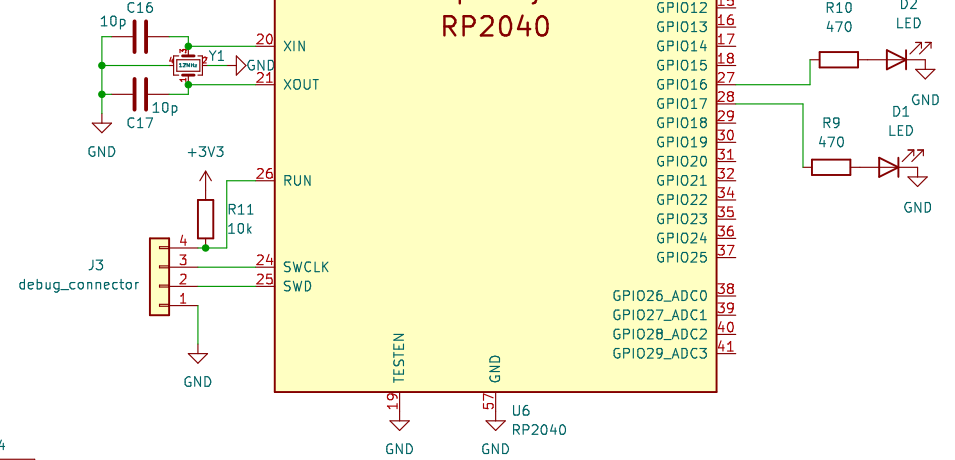
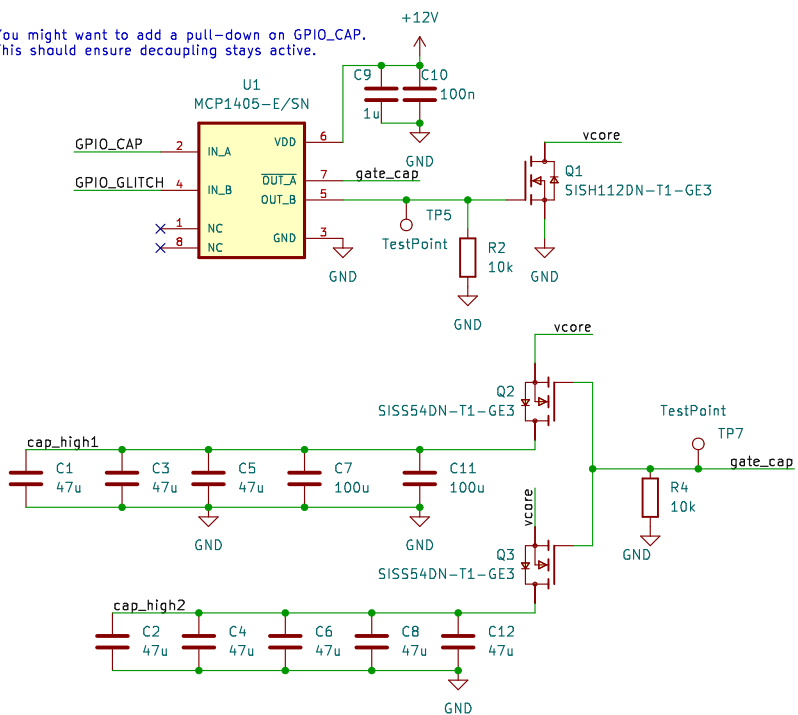
You might want to add a pull-down on GPIO_CAP.
This should ensure decoupling stays active.
